EMMY-W163 XPYEMMYW163 2016-09-09

Application to Class II Permissive Change

This request is to add one antenna and two trace design changes to the EMMY-W163 module with FCC ID XPYEMMYW163. The trace designs and antenna are included in a product commercialized by one of u-blox's customers. No hardware changes have been made to the EMMY-W163 module. NFC is not used in this customer's product.

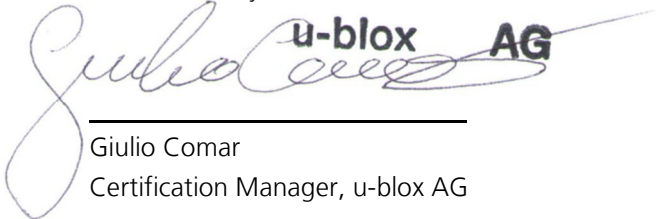
On the Bluetooth antenna port there is a trace design change. The Bluetooth antenna is previously used in u-blox reference design:

Manufacturer	Antenna p/n
Johansson	2450AT45A100
